STATE OF NEBRASKA
DEPARTMENT OF ROADS
ADDENDUM NO. 1
AND
ELECTRONIC BIDDING SYSTEM
AMENDMENT NO. 1
PROJECT NO. RD-75-3 (1013)
CONTROL NO. 31413
CALL ORDER N04
US-75, DECATUR NORTHWEST
LETTING DATE: OCTOBER 25, 2001

TYPICAL CROSS SECTIONS

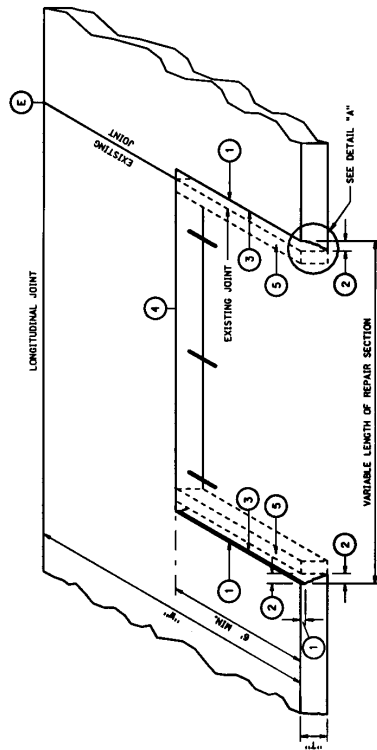
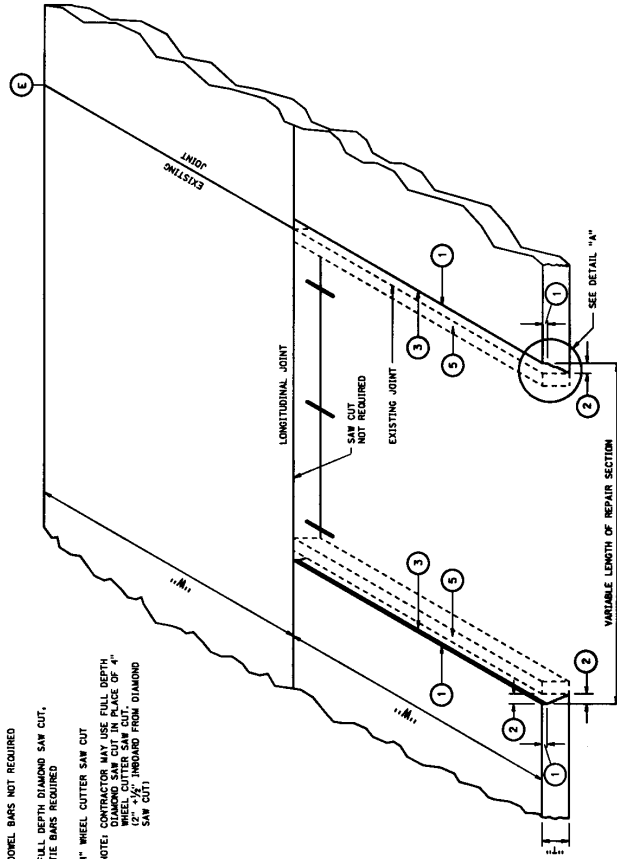
The plans are amended to include the attached plan sheet 2T6.
